**MAINE TURNPIKE AUTHORITY**

**ADDENDUM NO.2**

**CONTRACT 2018.14**

**KENNEBUNK AND GRAY  
MAINTENANCE GARAGE EXTENSIONS**

**253-SA-125**  
**OIL / WATER SEPARATOR**  
**125 GALLON - API STYLE**

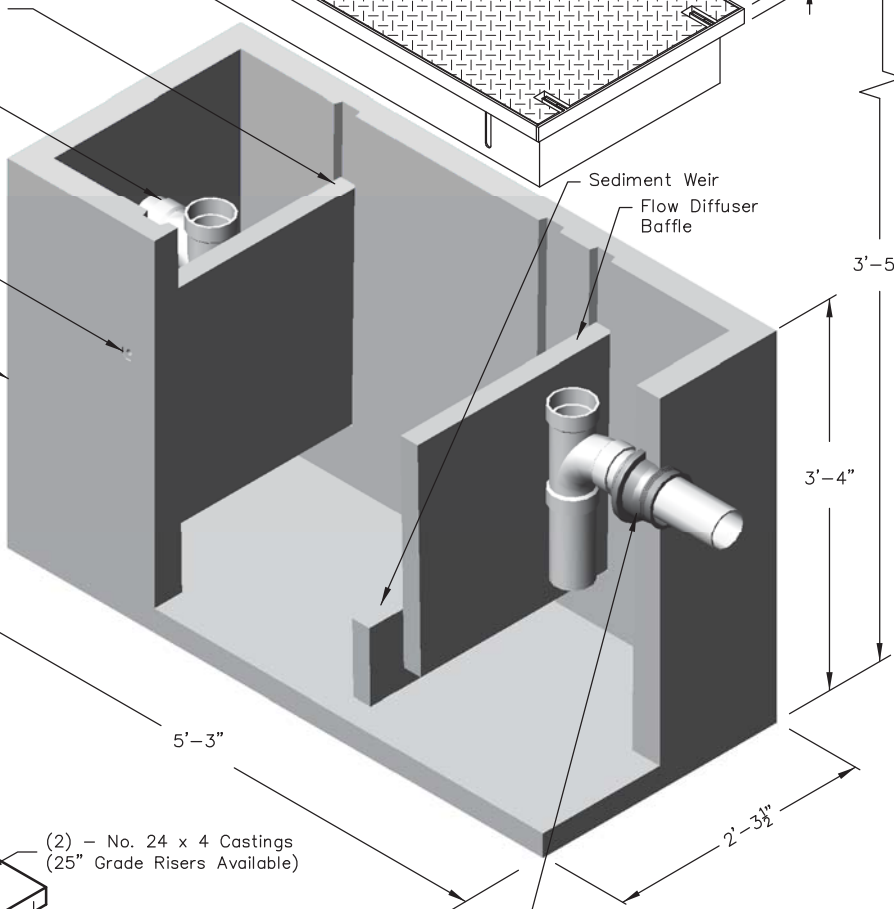
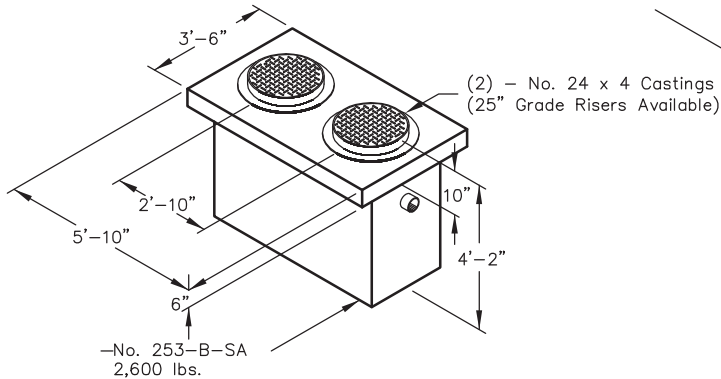
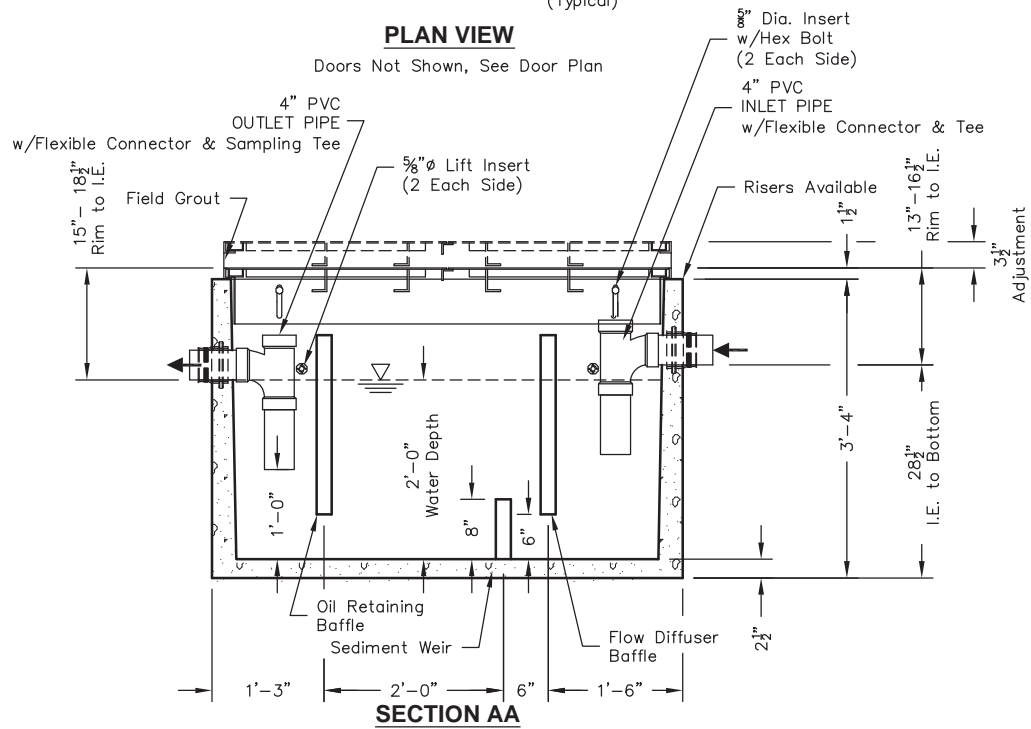
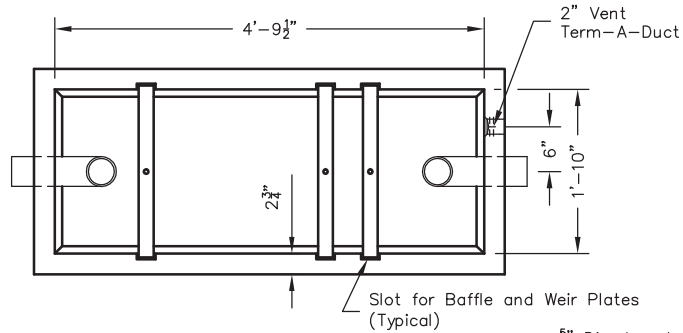
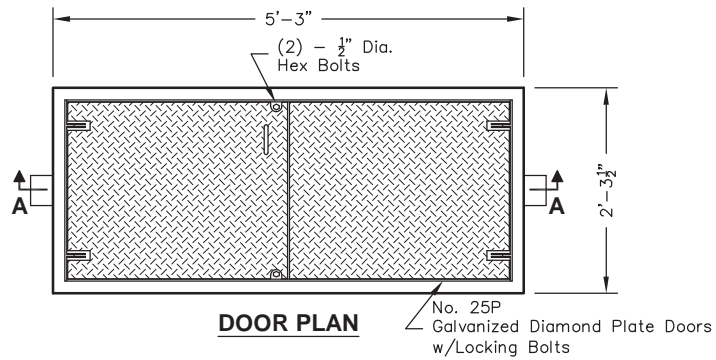
**Question 2:** In reference to sheet 14 of 27, note 3, a 125-gallon oil/water separator tank is not readily available. There are no other specifications or details of the tank provided. Can a product description, additional specifications or details be provided?

**Answer:** See attached Oil/Water Separator Tank detail. Contractor shall provide a Heavy Traffic top for the tank.
